## MEMO

TO: Pinellas Plant Work Group  
FROM: SC&A, Inc.  
DATE: February 3, 2016  
SUBJECT: Draft Pinellas Issues Matrix Issue #5: Gamma LOD for RTG Pu-238 Generators

Figure 4-8. Ratio of Number of Gamma Escaping the RTG to Number of Gammas Produced in the Fuel for a Pair of SNAP-19 RTG's at 20° to the Longitudinal Axis.

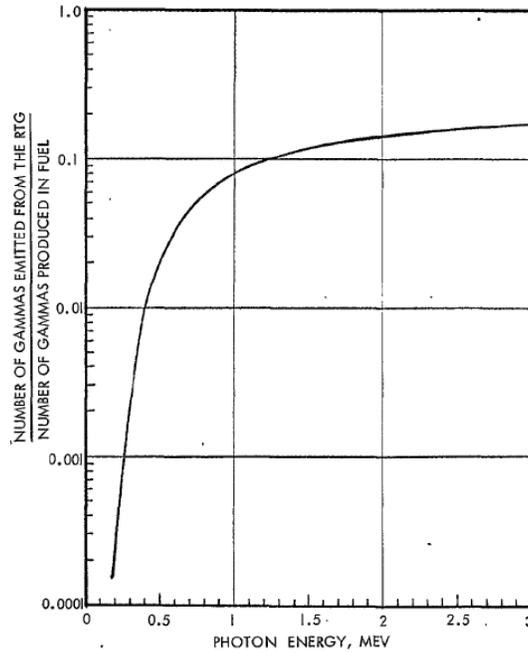
Figure 4.8 from the report (above) describes the gamma flux leaving the cell. It can be seen that the majority of the flux will be above 500 keV.

Figure 4-10. Gamma Dose Rates vs. Distance From the Center of a SNAP-27 Capsule

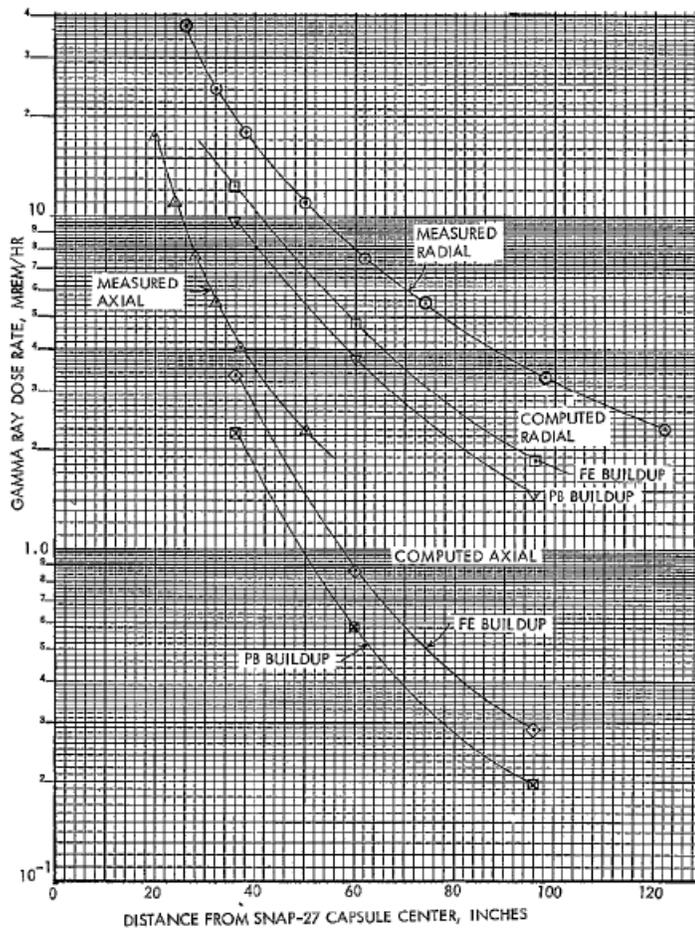
Figure 4.10 from the report (above) shows the dose rates at various distances from the generators. At 20 inches, 25–35 millirem per hour (mrem/hr) is measured. This dose rate will vary with geometry and the source/age of the fuel. However, this graph gives an indication that personnel exposures could have been significant at typical distances at which a worker would manipulate tools and equipment.
